Lake Geraldine Dam Iqaluit, Nunavut Dam Safety Inspection

November 23, 2010 REPORT

THE CITY OF IQALUIT

CONCENTRIC ASSOCIATES INTERNATIONAL INCORPORATED

Photograph 2
Overview of North Berm, Downstream Face. Note leakage just north of ramp access.

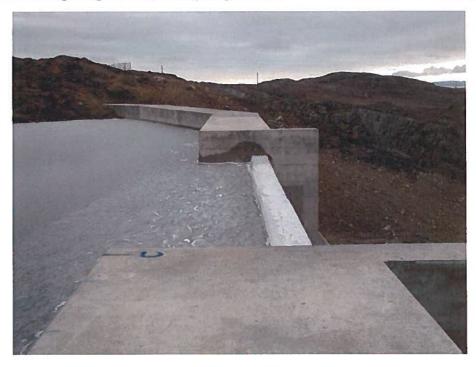
Through leakage in the north berm was observed on both the north and south sides of the vehicular access ramp.

- 3. The through leakage in the north berm at the vehicular access ramp requires investigation and repair in 2011. An investigative program will be prepared if requested by the City.

Photograph 4 Southern portion of North Berm, upstream face; note localized washouts due to wave action.

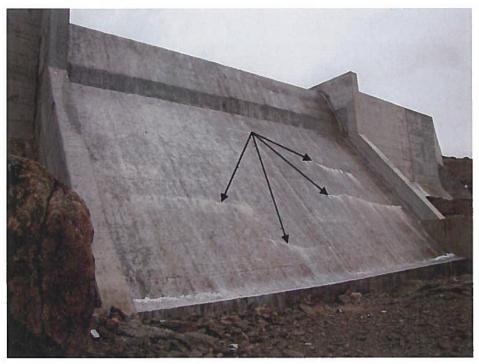
- Localized wash-outs have occurred on the upstream face of the north berm. It was reported that these wash outs developed as a result of wind events during the week of October 18, 2010. The larger armour stone remains however sections of the roadbed have been washed out.

- 2. The localized wash outs from the wind events of 2010 require repair. As a short term interim measure all areas of erosion should be filled with rock of similar size to the existing rock fill. In the longer term, the upstream berm should be filled with rock up to and slightly above the top of the cutoff wall, and thus eliminate a 1.2 metre width of the vehicular roadbed.
